## *Addendum to* PowerPC 604™ RISC Microprocessor User's Manual: **PowerPC 604e™ Microprocessor Supplement and User's Manual Errata**

This addendum to the *PowerPC 604 RISC Microprocessor User's Manual* is in two parts:

- Part 2: Errata to *PowerPC 604 RISC Microprocessor User's Manual* contains corrections to the user's manual.

**Figure 9-1. MESI Cache Coherency Protocol—State Diagram (WIM = 001)**

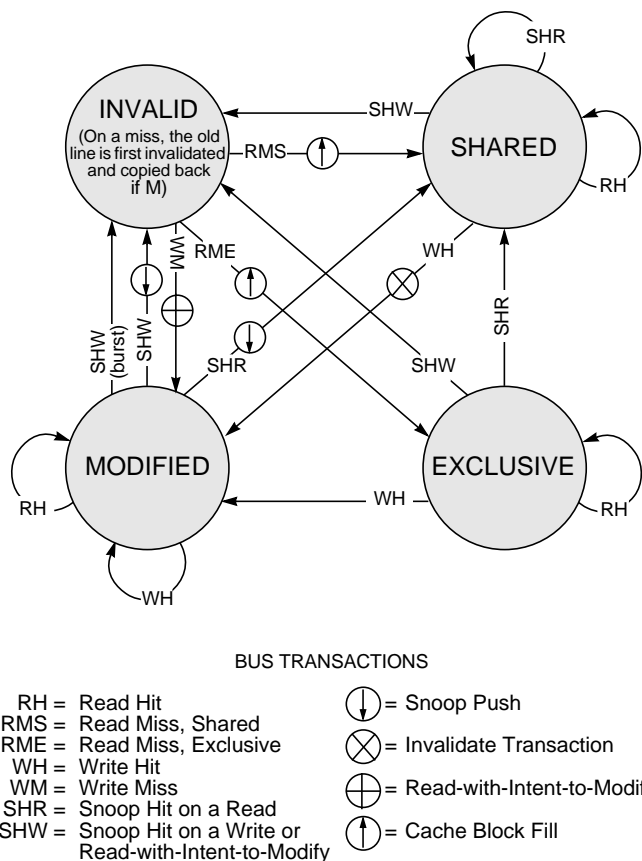
3.6.4, Page 3-14      The following should replace Figure 3-6 and Figure 8-15 in Chapter 8.

**Figure 8-20. Burst Transfers with Data Delay Controls**

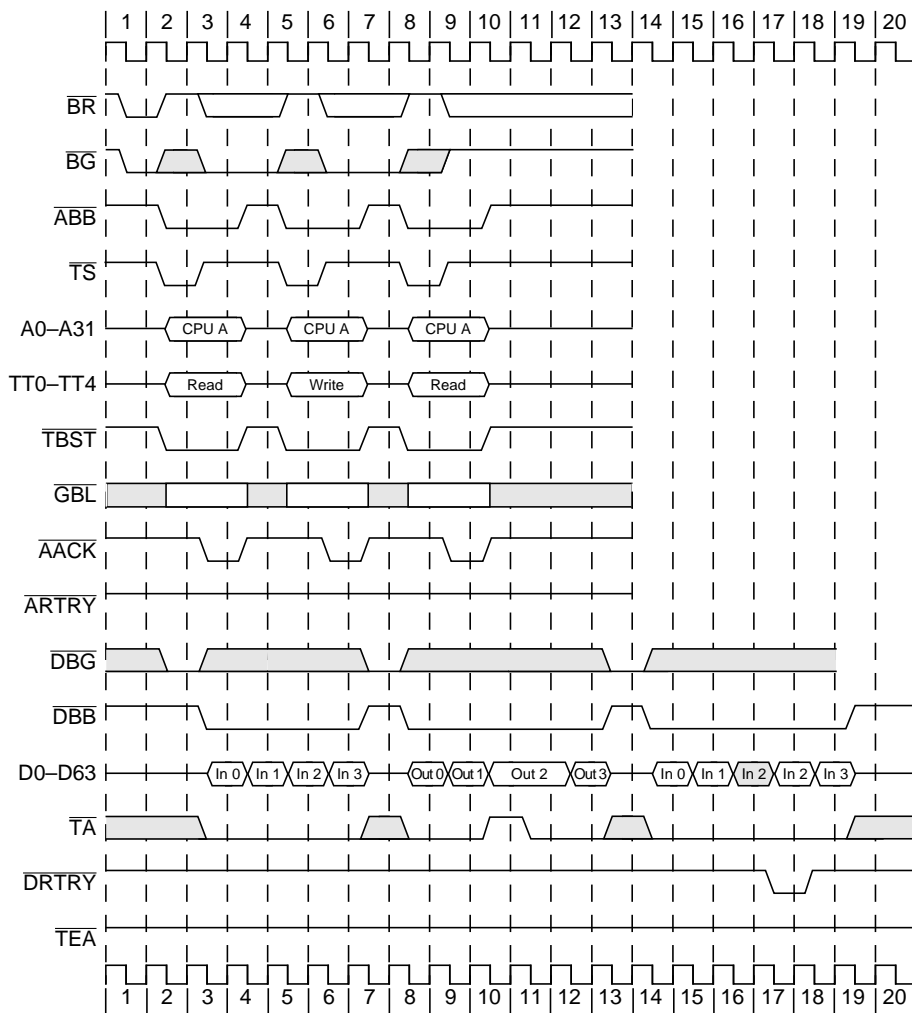
8.5, Page 8-36      Replace Figure 8-20 with the following:

**Figure 8-21. Use of Transfer Error Acknowledge (TEA)**

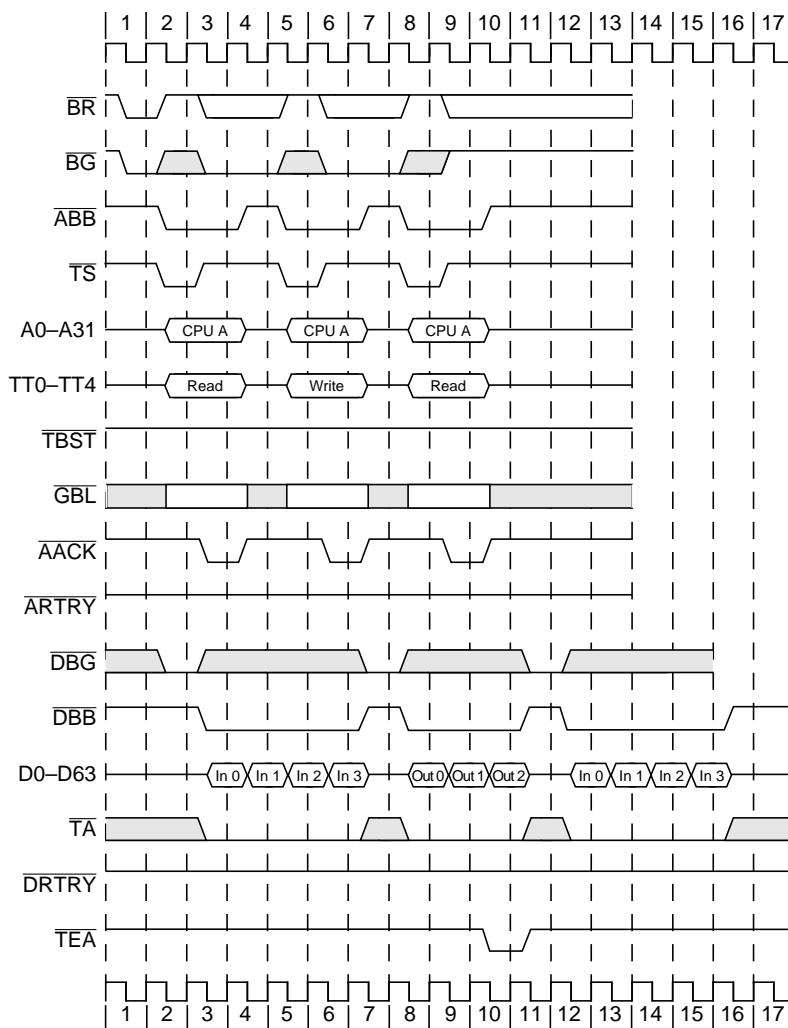
8.5, Page 8-37      Replace Figure 8-21 with the following:
